Waterview Connection Project Board of Inquiry

Freshwater Ecology Review Appendix to the Section 42A Report

Prepared by Dr Gregory Ian Ryder

Figure 2 Relevant sub-plans which detail mitigation of potential impacts from construction activities on the aquatic receiving environment (Figure 1-1 redrawn from the Ecological Management Plan).

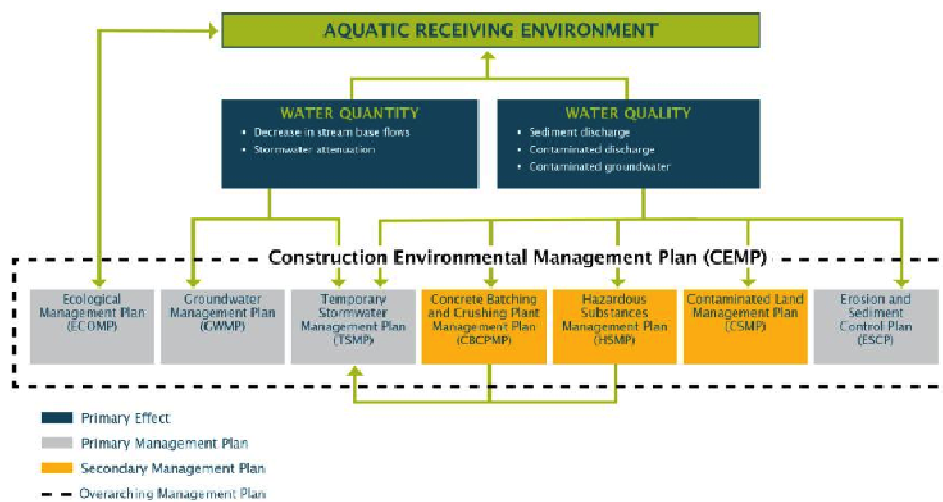
8.2 An "Ecological Management Plan" (ECOMP) has been developed to manage and monitor the ecological values in the Project area. It includes a freshwater monitoring programme with two primary components: "devices" monitoring and habitat monitoring. Trigger events for device

8.4 The variables to be monitored in this programme, together with their frequency, appear adequate. The Auckland Regional Council submission has requested that fish and macroinvertebrate monitoring be undertaken during the summer months. I recommend that this monitoring be undertaken in both summer and winter to account for potential seasonal changes particularly for fish.
